**Re: Lost Creek Project,
NRC License SUA-1598, Docket No. 40-9068
Amendment Application for inclusion of Yellowcake Vacuum Drying**

**Vacuum Dryer Amendment Supplement
to the
Lost Creek ISR, LLC
Technical and Environmental Reports**

FIGURE 1.5-2b
Plant Process Flow
Lost Creek Permit Area

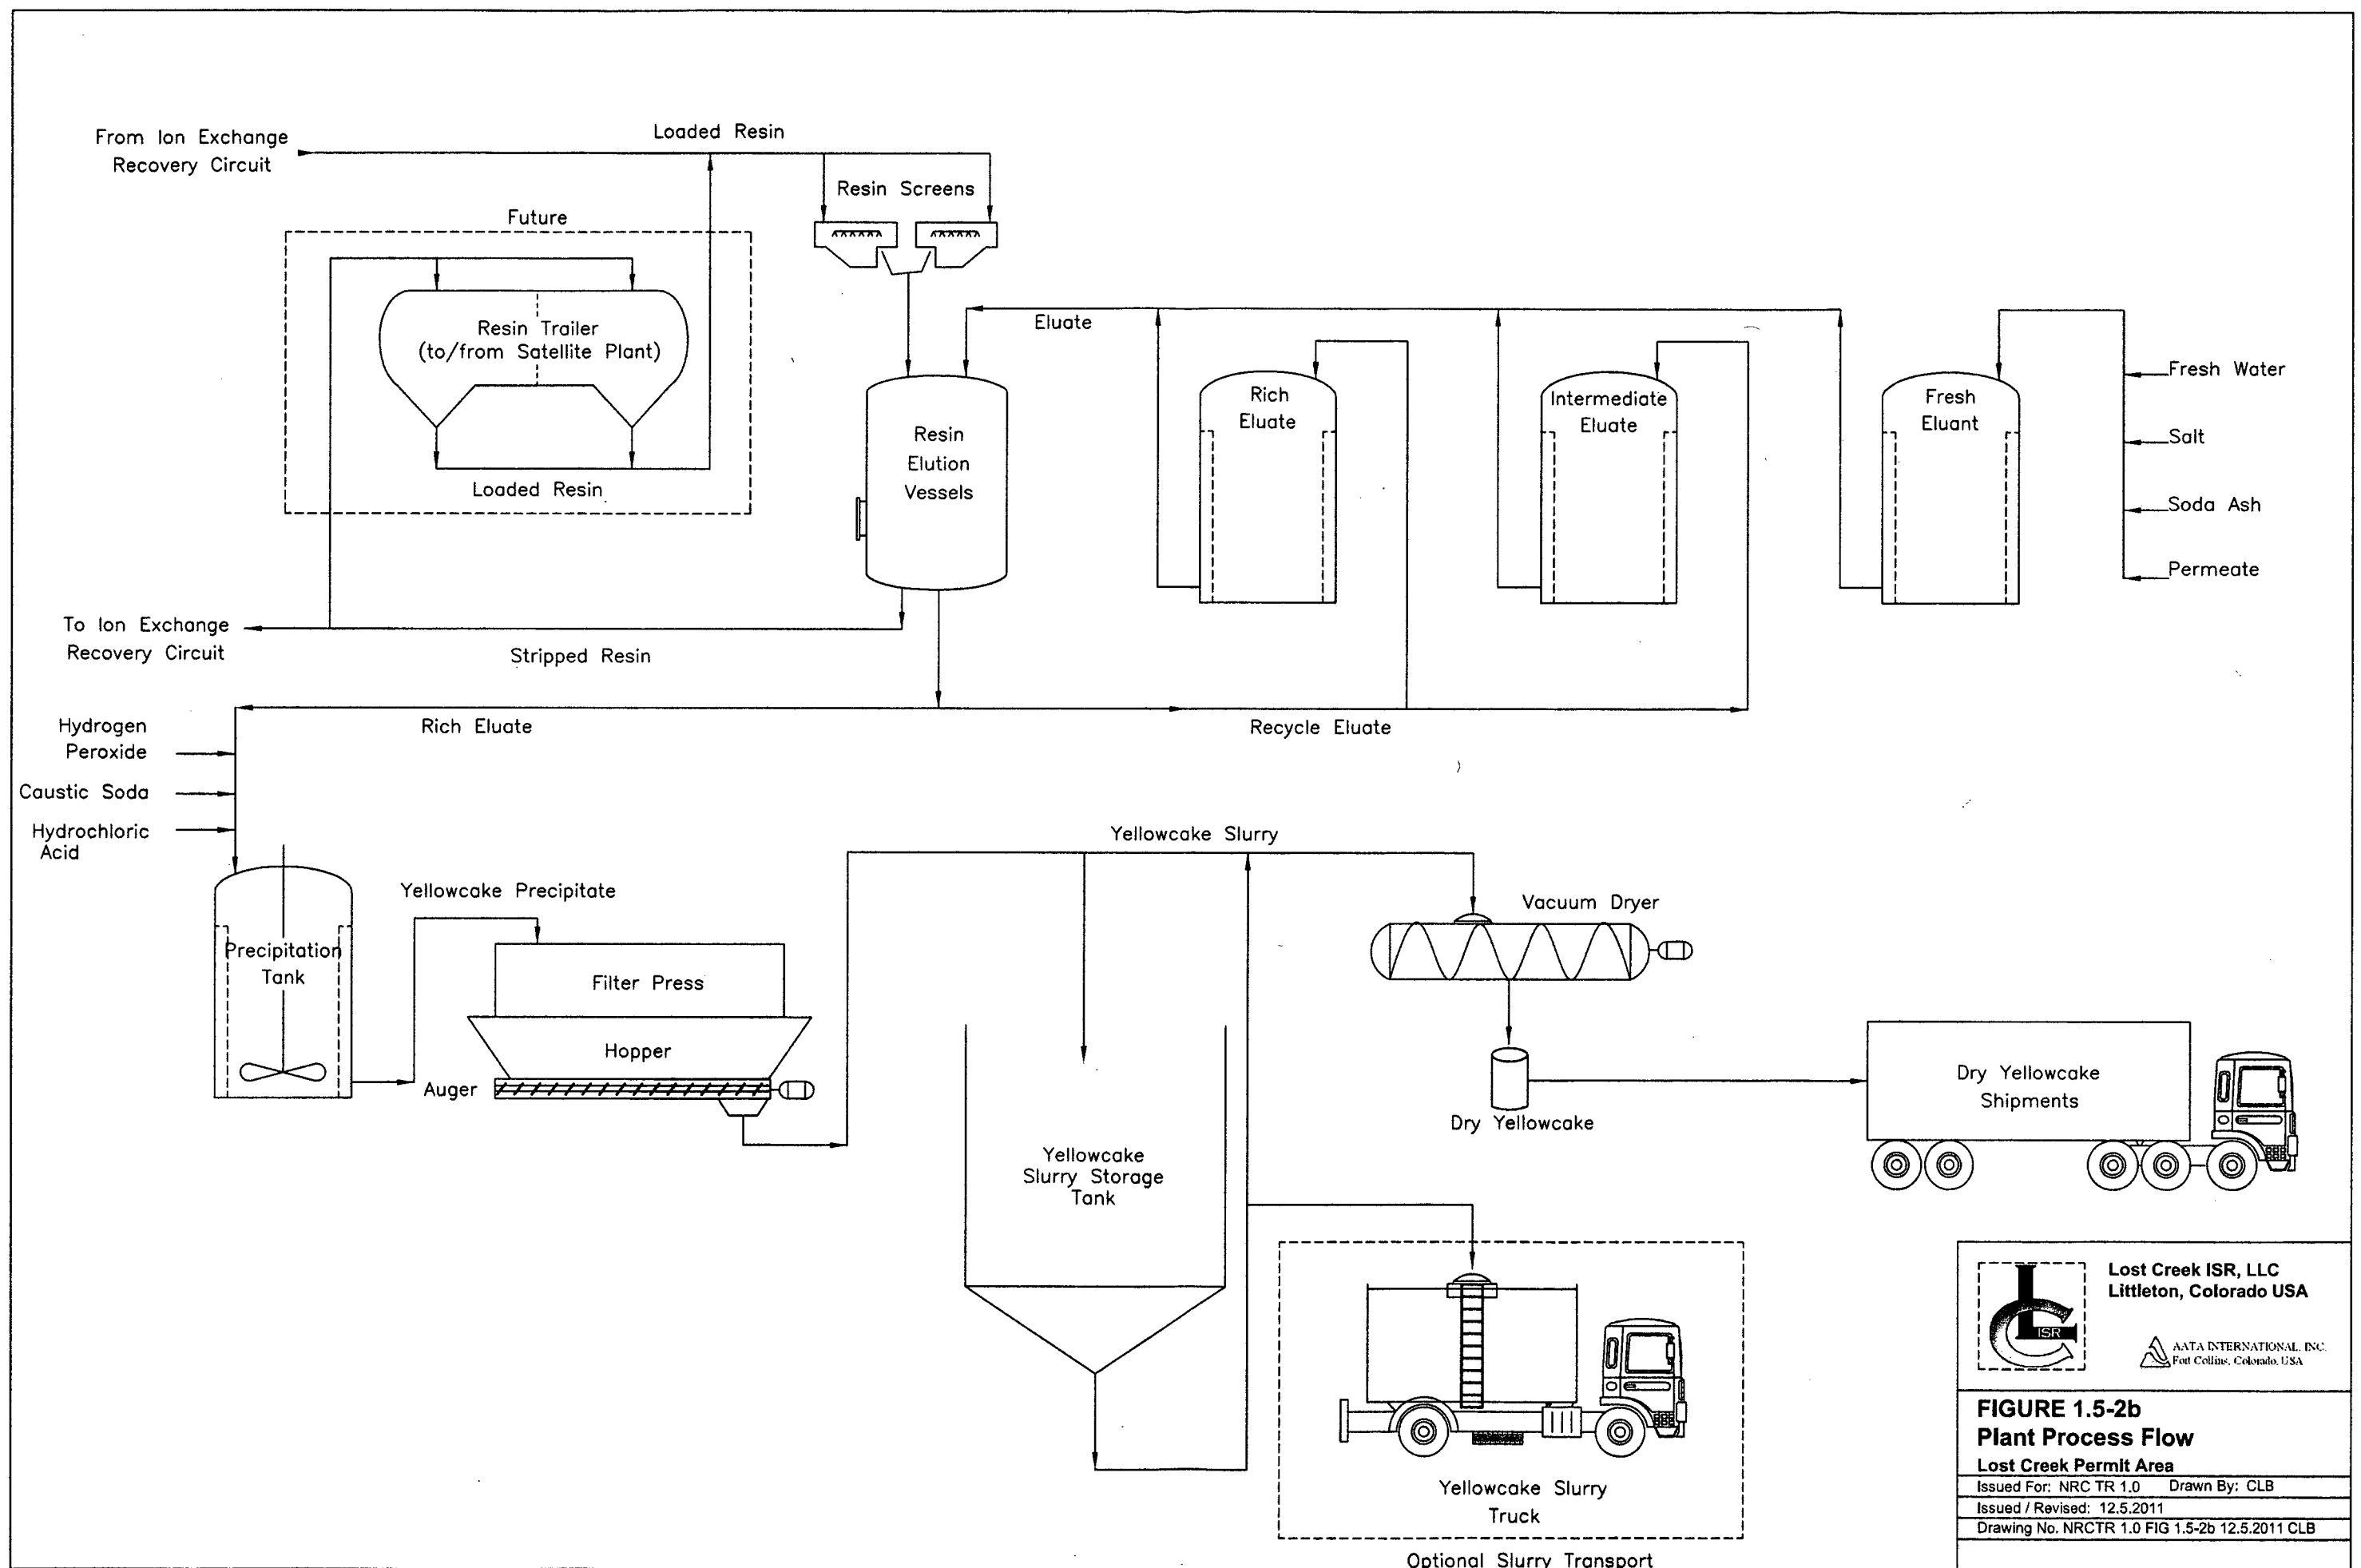
This Amendment adds a Rotary Vacuum Yellowcake Drying process to the overall recovery process as a Dryer Circuit within the Central Processing Plant (CPP). The Dryer Circuit and drying process are described in detail below in the "Supplement to TR Section 3.0 Description of the Proposed Facility". Revised Technical Report (TR) Figure 1.5-2b (Revised Environmental Report (ER) Figure 1.2-6c) is attached to illustrate the amended process.

This Vacuum Dryer Amendment hereby adds a dryer circuit to the CPP design and plant operations. The dryer circuit supplement for this ER Section is provided above in "Supplement to TR Section 3.0 Description of the Proposed Facility". Revised TR Figure 1.5-2b is attached to show the amended CPP process including the dryer circuit. Thus Revised TR Figure 1.5-2b supersedes ER Figure 1.2-6c. Revised TR Plate 3.1-1 is attached to show the amended CPP layout including the dryer circuit. Thus Revised TR Plate 3.1-1 supersedes ER Plate 1.2-1.

Dryer Flow Diagram

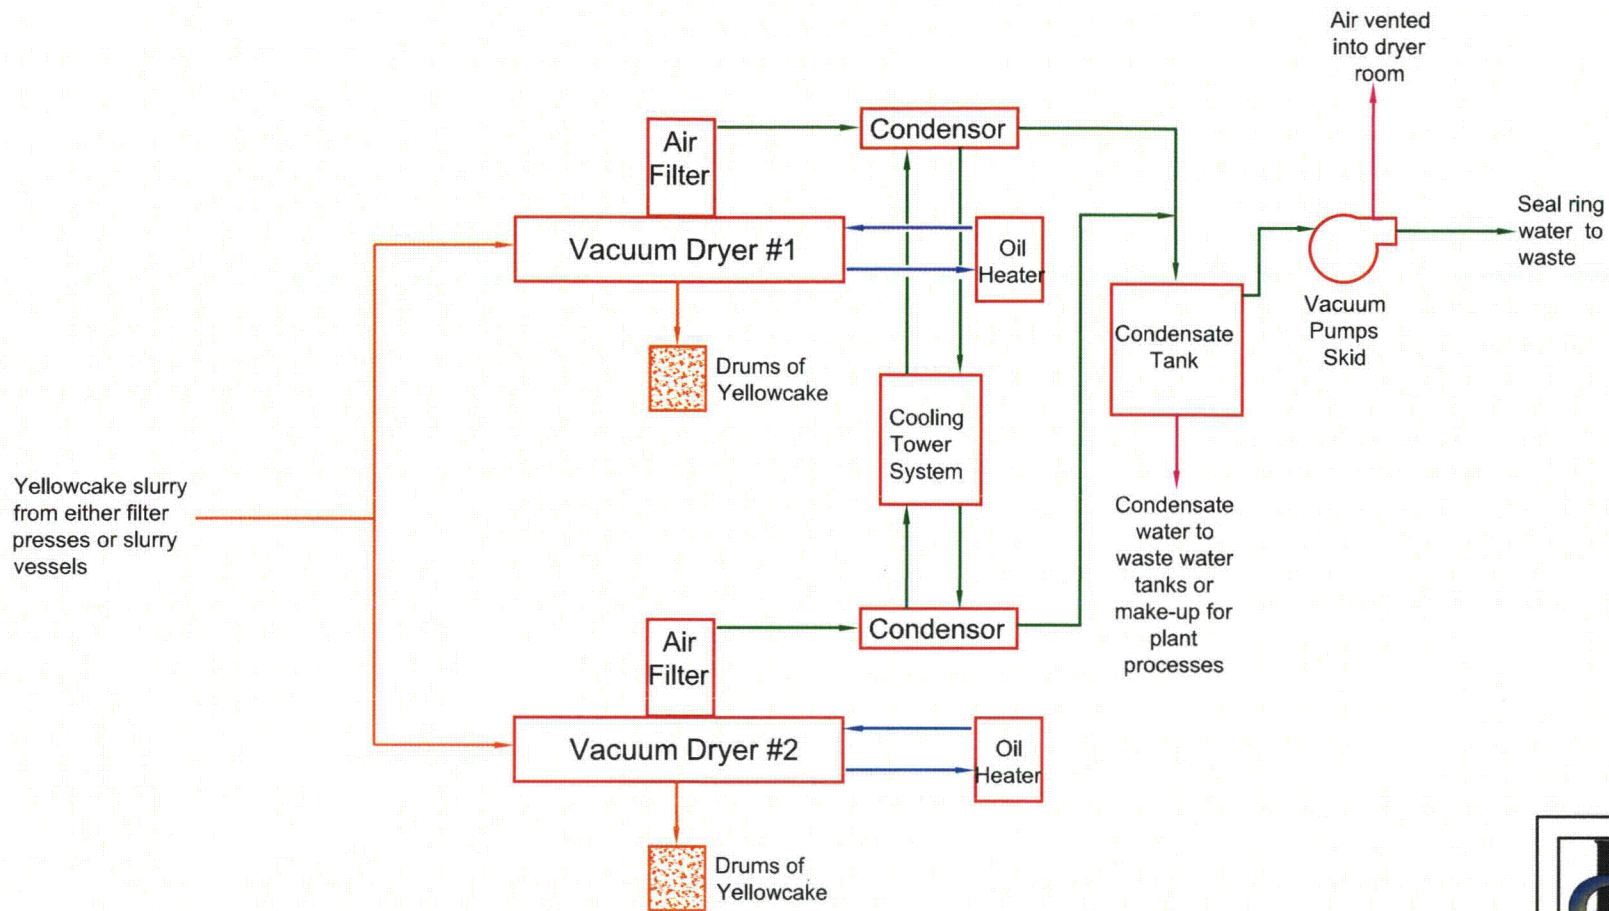
The Lost Creek Plant drying circuit will be comprised of up to two separate drying systems. This allows the plant operations department flexibility to vary the output of dried product in the case of increased production rates or changes in scheduled maintenance. The dryers will be a standard rotary vacuum design. The dryer room in the CPP will have its own ventilation system in order to prevent any dry yellowcake particulate from being circulated into other areas of the plant. The dryer circuit ventilation design provides the dryer room with negative pressure, forcing flow into the room. Vacuum dryers are designed to have no emissions. The attached "Dryer Flow Diagram" illustrates that the vacuum drawn through the dryer passes through a bag

filter, a condenser, vacuum pumps with a water seal and a condensate tank. There will not be a discharge stack associated with the dryers and final venting from the vacuum pump will be back into the dryer room.

FIGURE 5.7-1
LOCATIONS OF IN-PLANT
RADIOLOGIC SAMPLING
Lost Creek Permit Area
Issued For: NRC TR Drawn By: CLB
Issued / Revised: 1.3.2012
Dwg No. NRC-TR-5.7-1-01-03-11-CLB

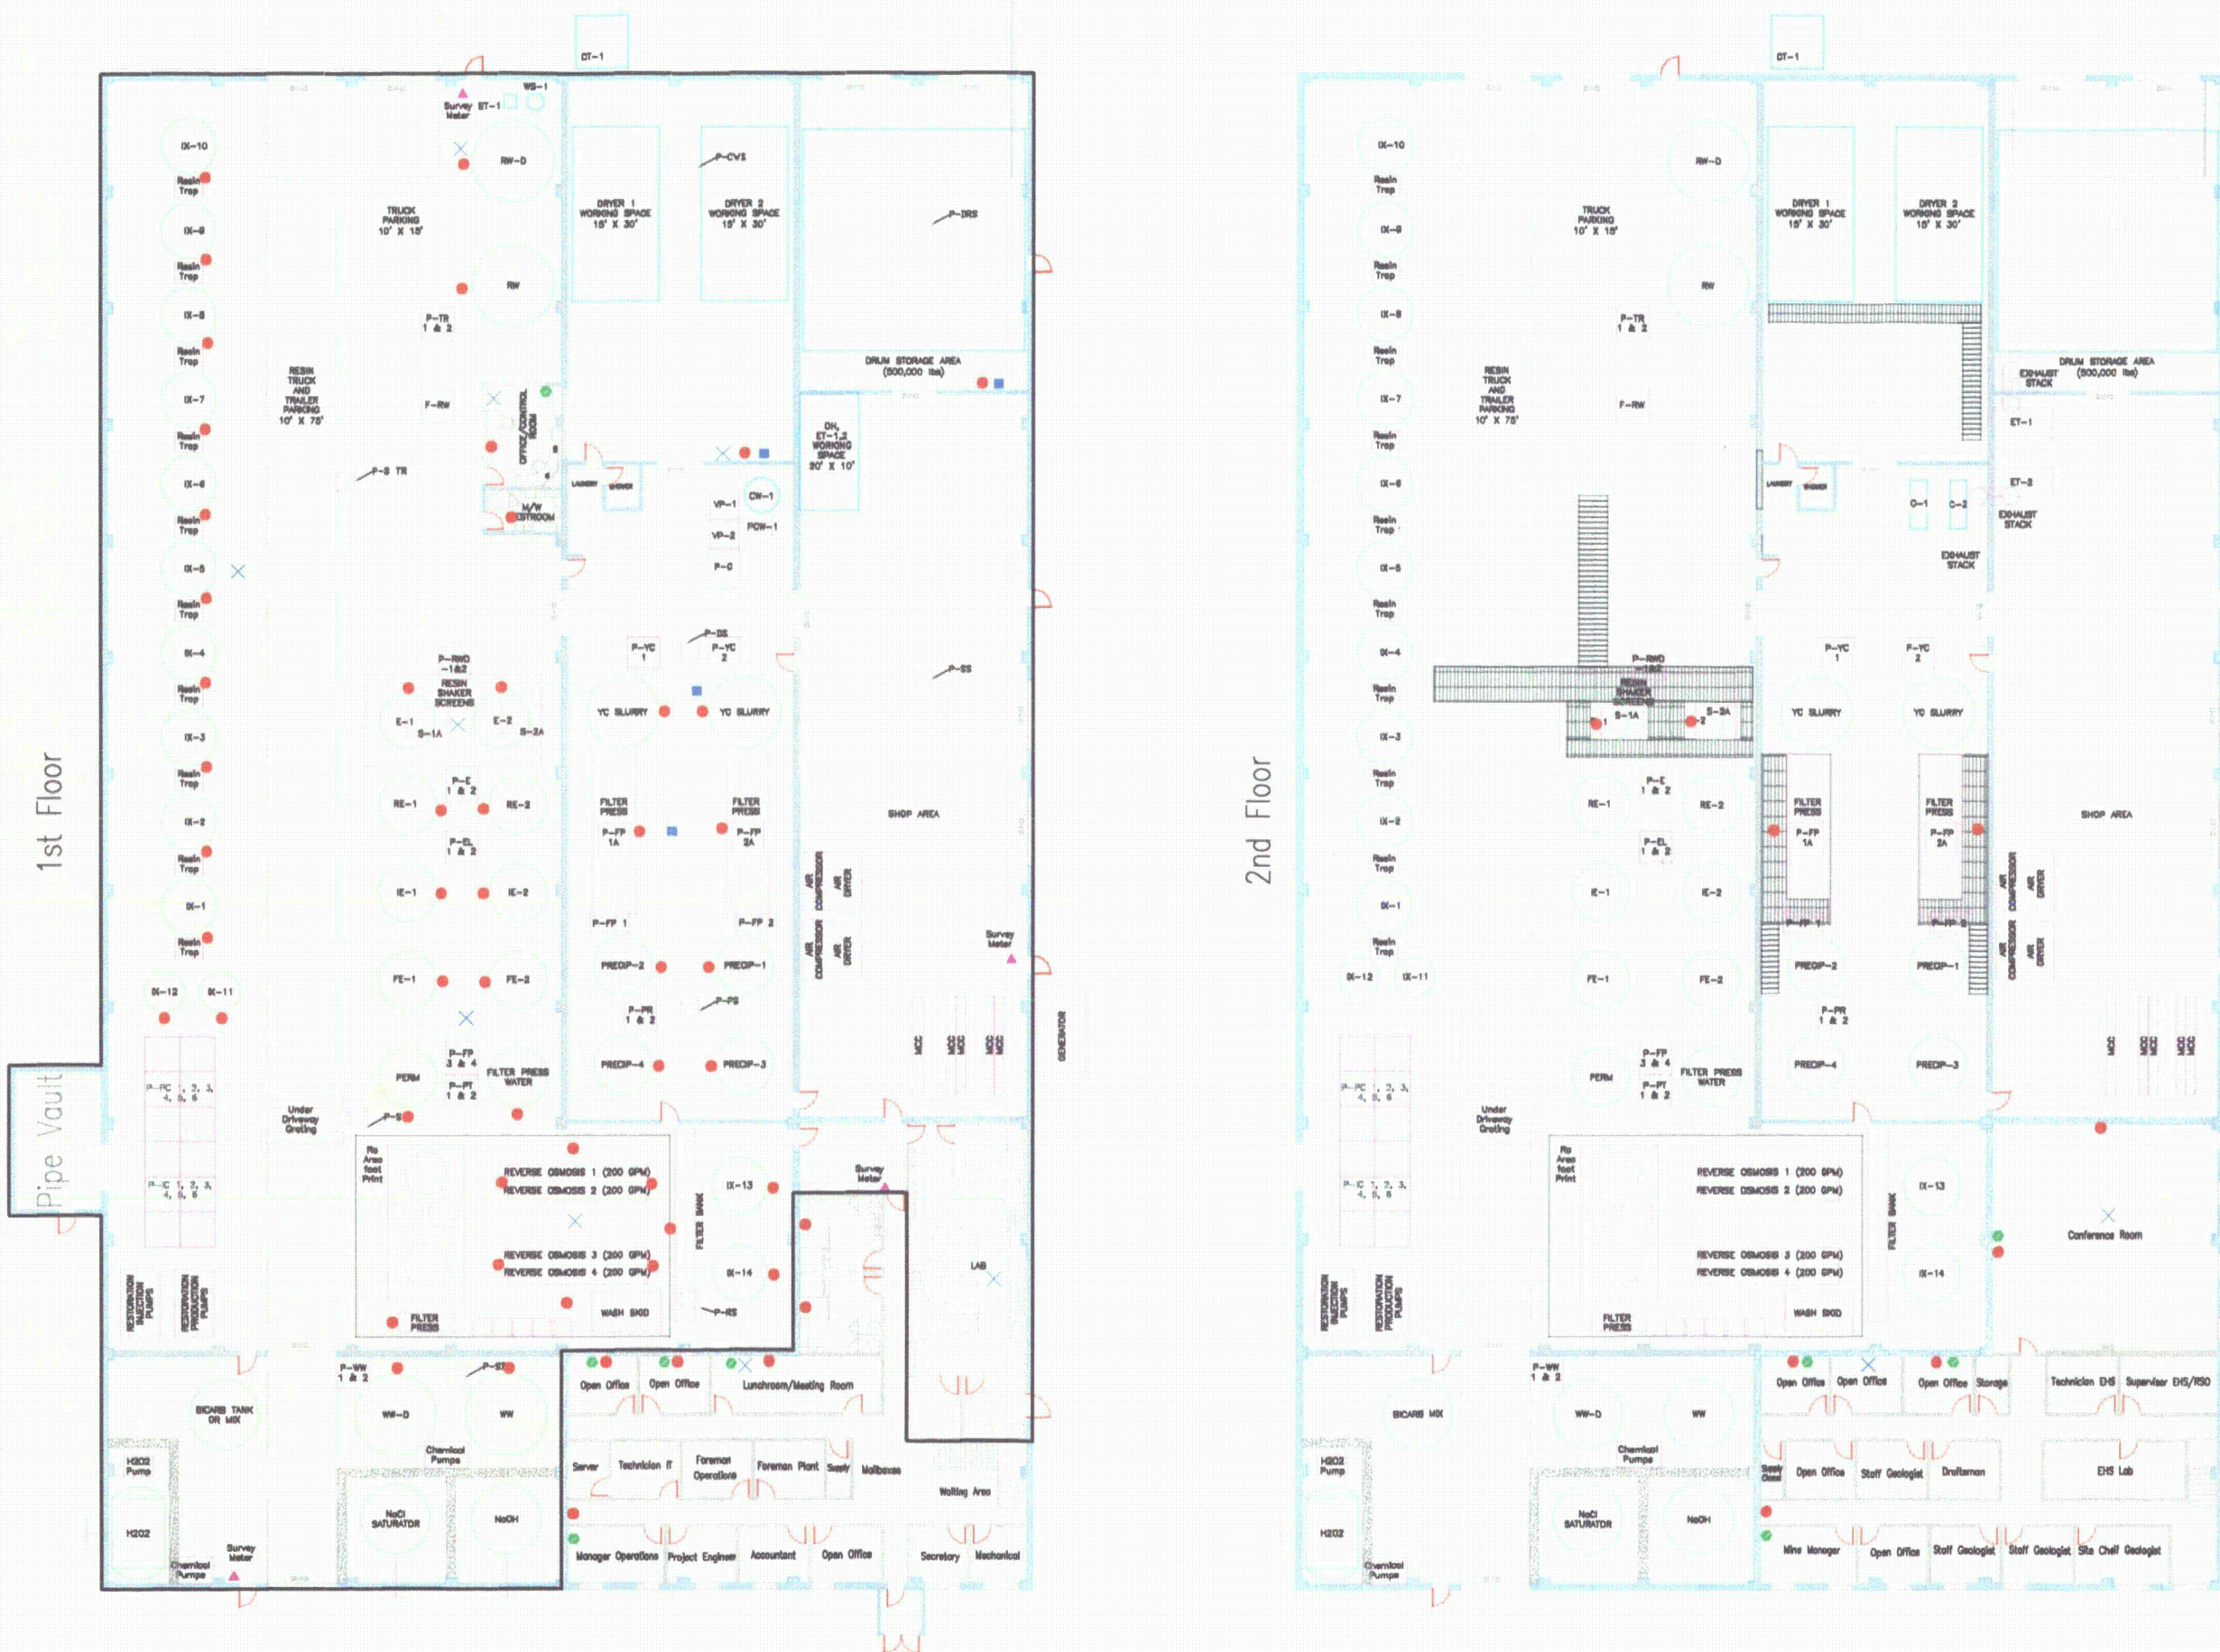
TR Section 5.7.6.2 is expanded to include the yellowcake drying area as one of the survey areas of concern where work with uranium is performed.
